28 September 2026

Section 16 Planning Application for Proposed Mixed-Use Development (Proposed Flat with Permitted Commercial Uses) with Minor Relaxation of Building Height Restriction at Lot 4354 in D.D. 124, Kiu Tau Wai, Yuen Long (Application No. A/HSK/617)

Response to Departmental Comments

Hydraulic Checking Layout Plan

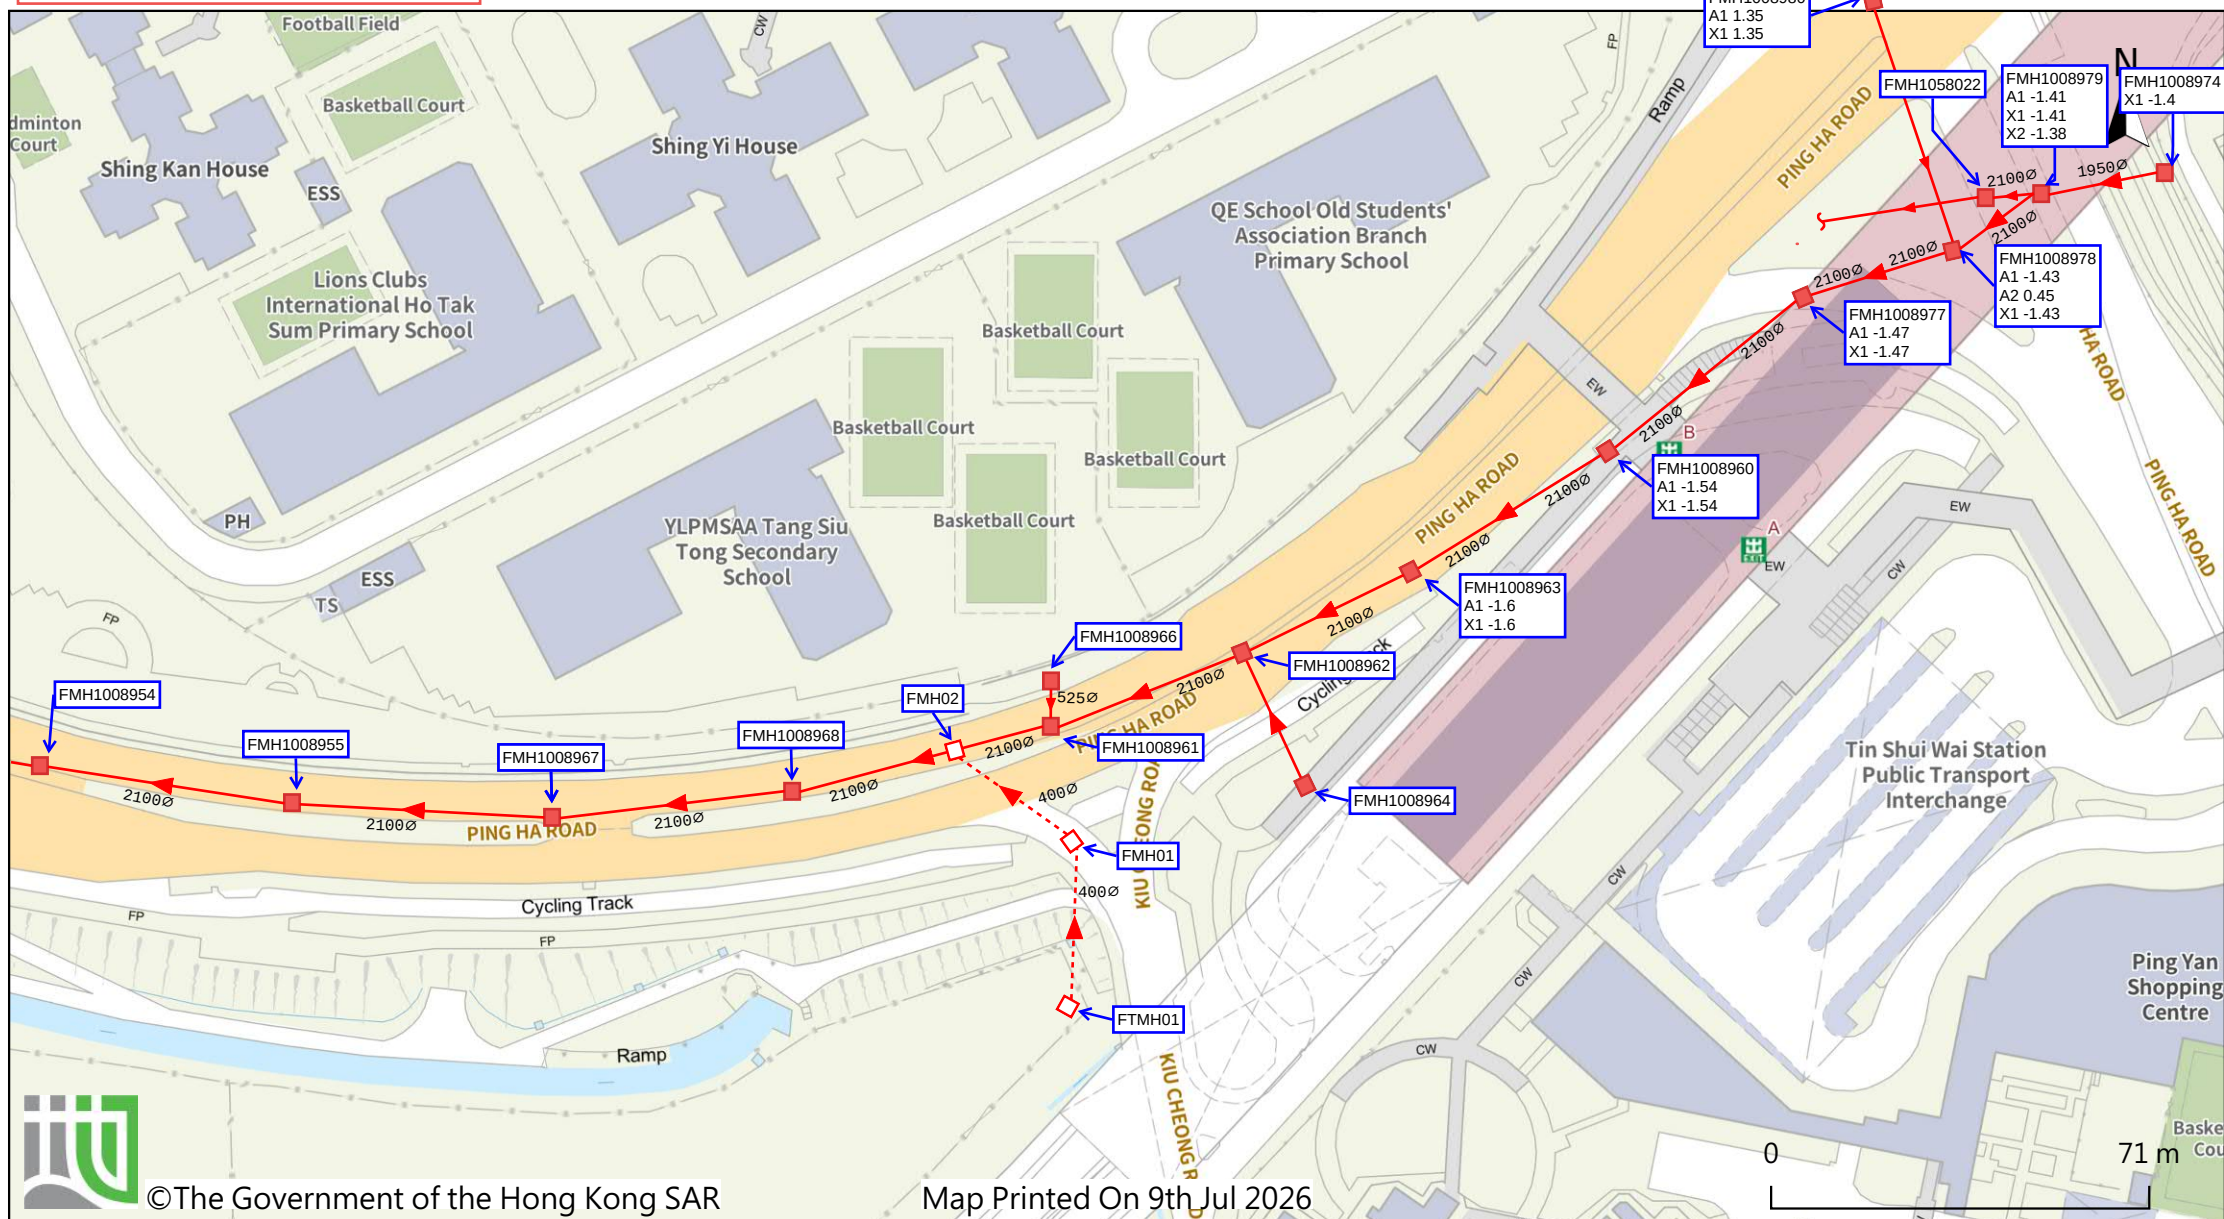
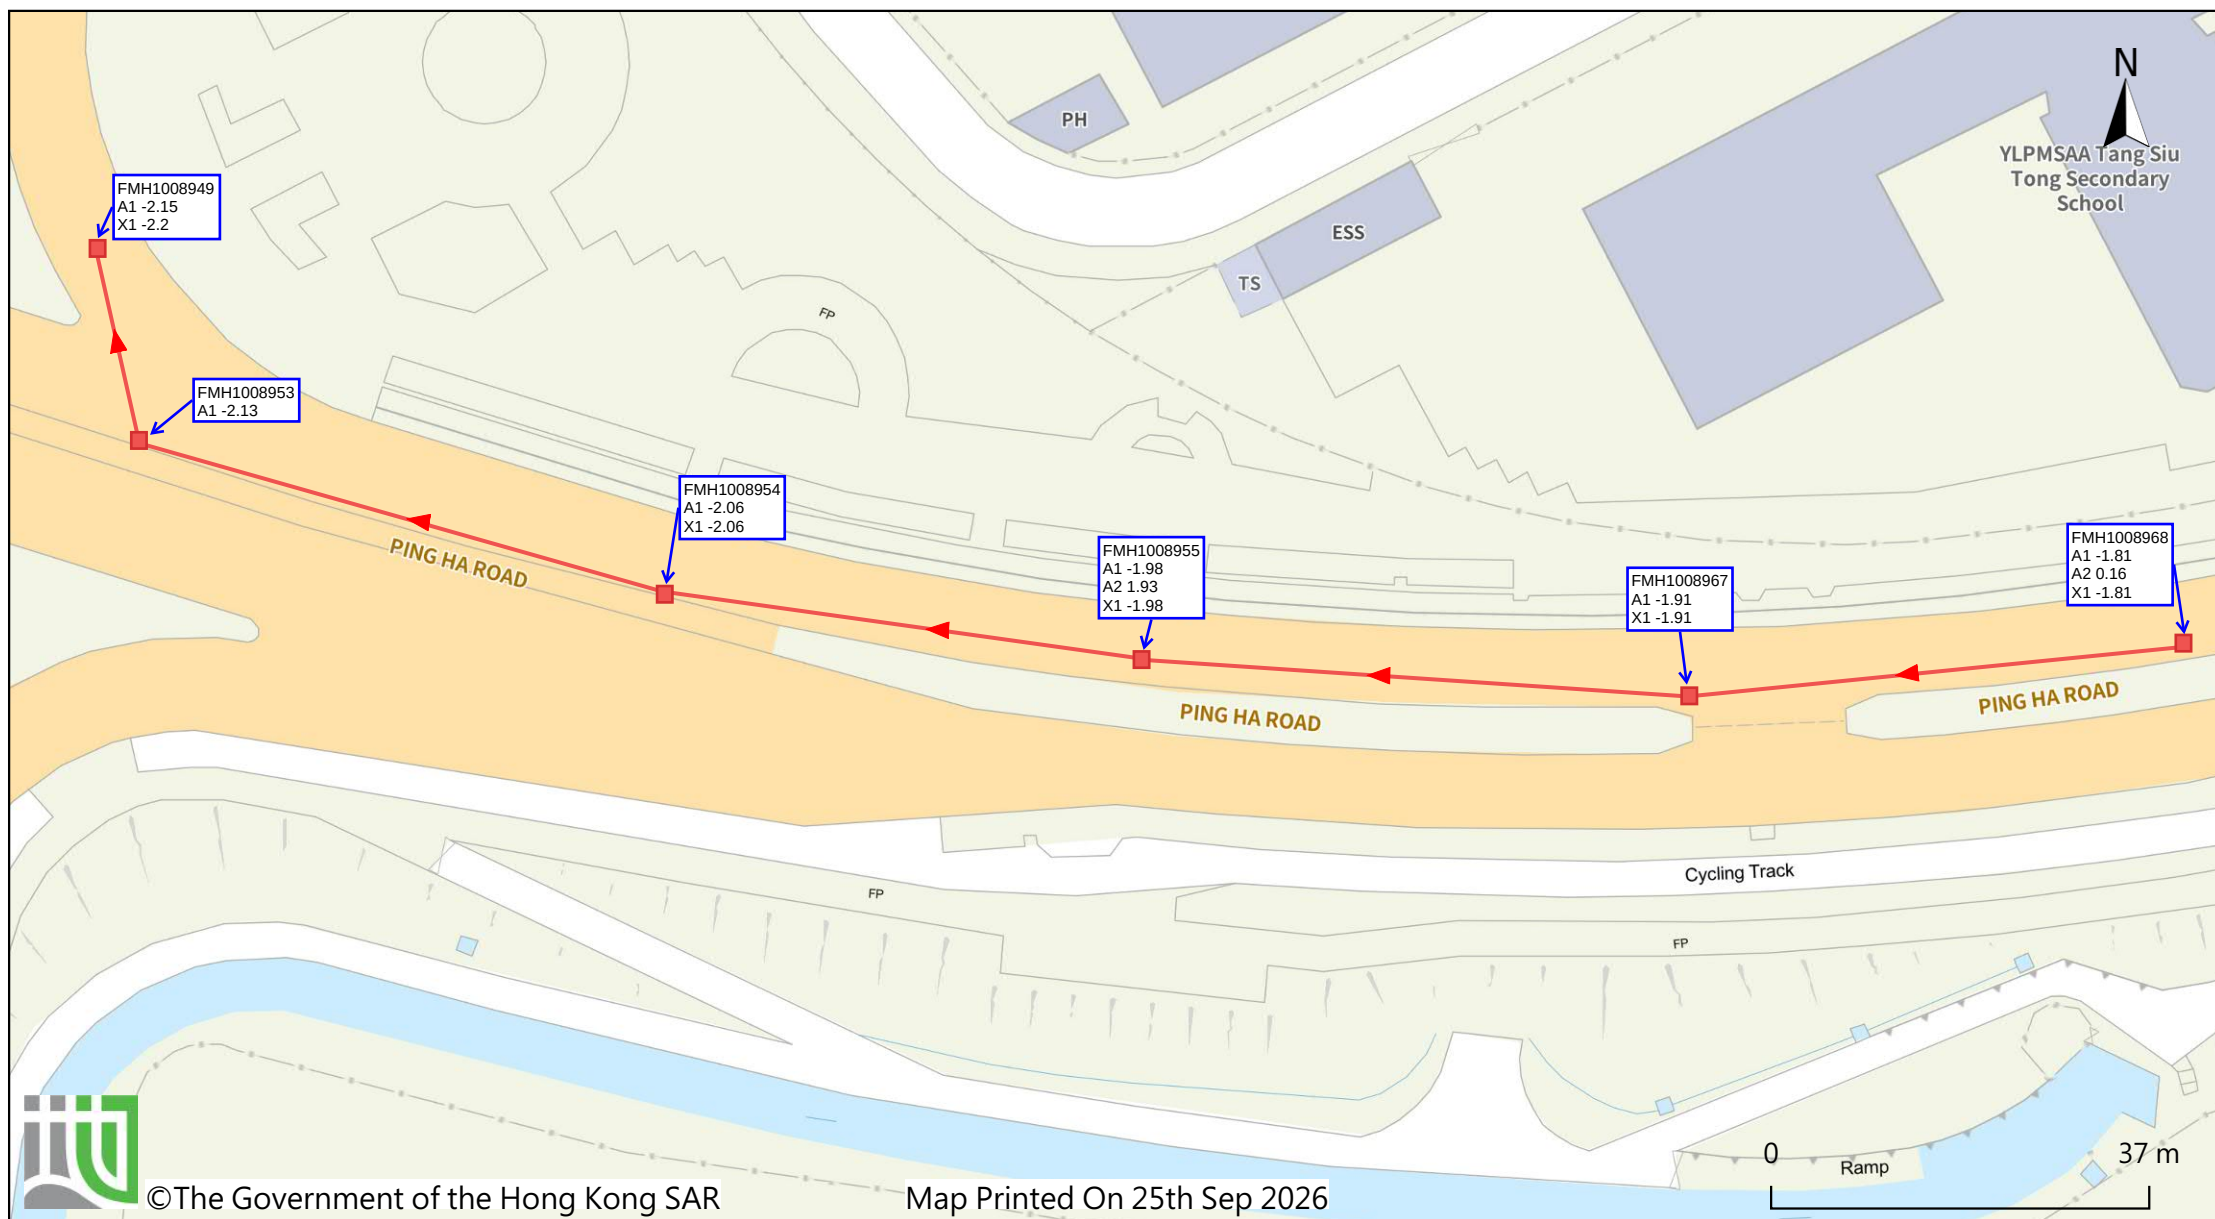
4.12	<u>Figures</u> Please ensure all sewers included in the hydraulic checking in Annex 2 are shown in the drawings.	A figure indicating the sewers included in the hydraulic checking has been supplemented. Please refer to the SIA replacement pages under Attachment 1 .

Figure: 2.2	RAMBOLL
Title: Propose Road Traffic Noise Mitigation Measures	Drawn by: KK
Project: Section 16 Planning Application For Proposed Comprehensive Development At Lot No 4354 In Dd 124, Kiu Tau Wai, Ping Shan, Yuen Long	Checked by: TC
	Rev.: 1.2
	Date: Aug 2026

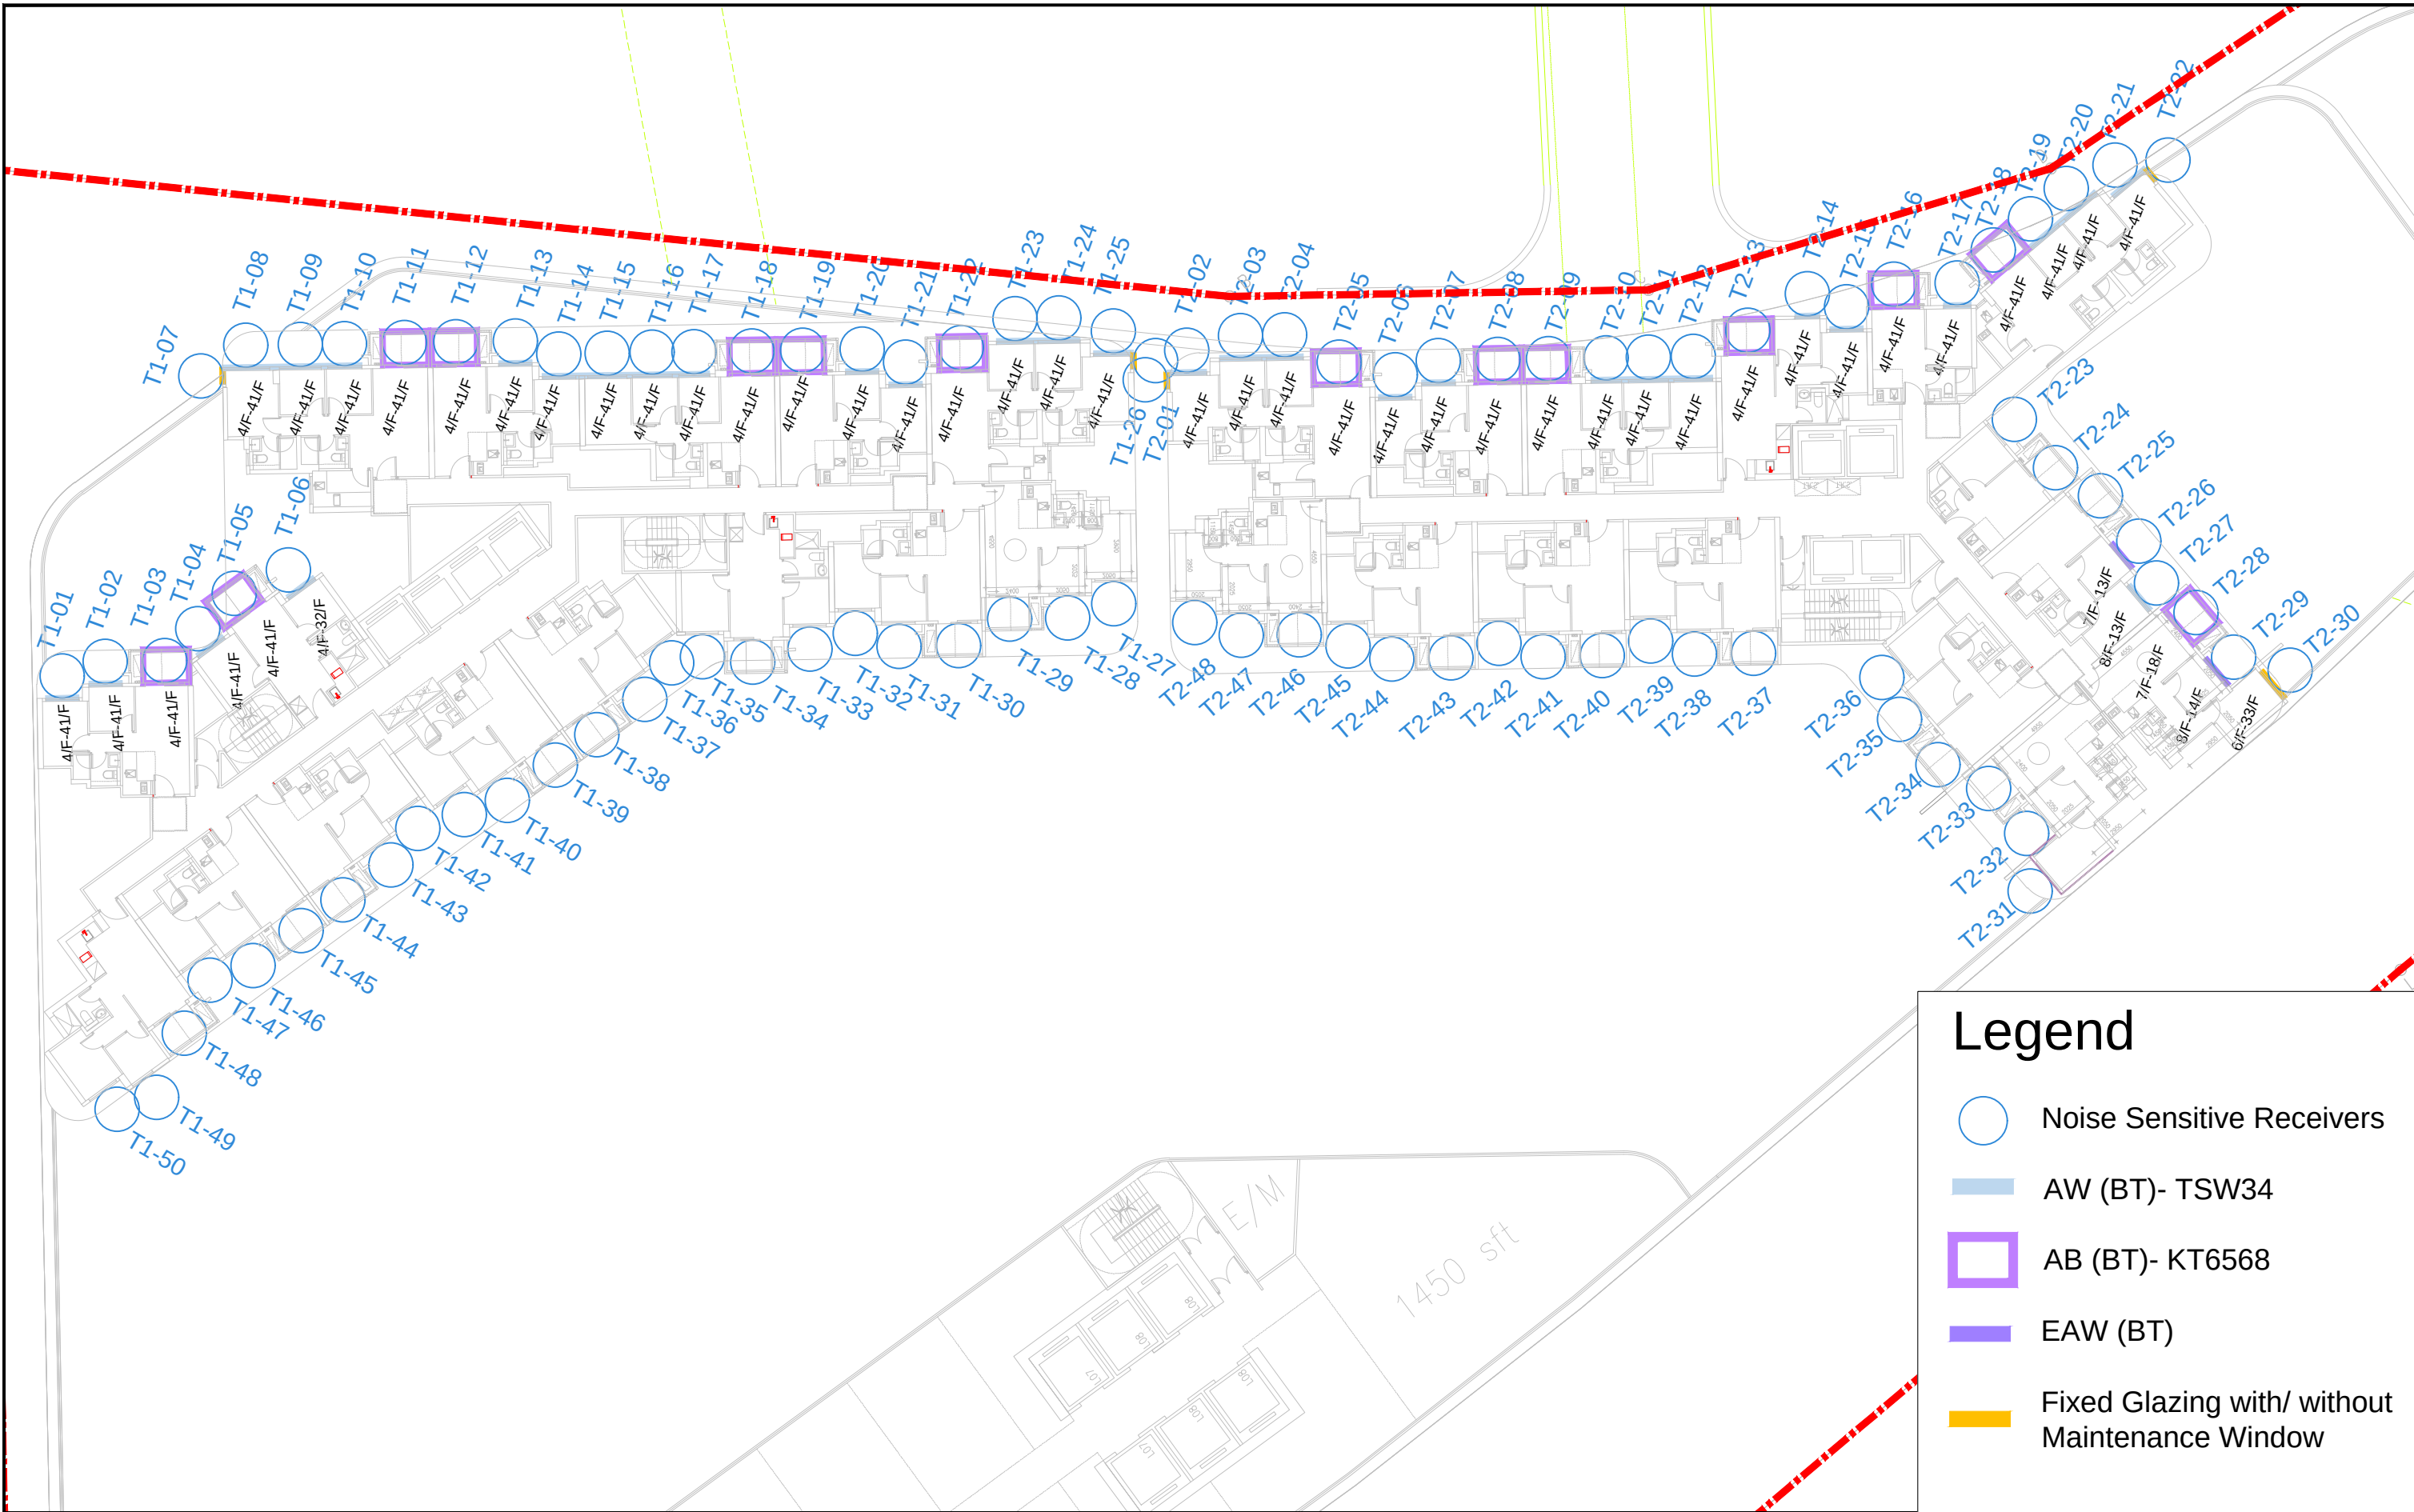
4.2	New proposed acoustic window at location without NAP assigned is spotted (between T229 & T2-30). Please clarify and revise. If new window opening is proposed, the relevant noise assessment should be resubmitted for detailed review.	Noted. The irrelevant information has been removed from Figure 2.2 . A detailed noise impact assessment, including road traffic noise, will be conducted in later stage when the actual design layout is available and will be submitted for the purpose to discharge relevant condition. Section 2.10.4 has been updated accordingly. Please refer to the EA replacement pages in Attachment 2 .
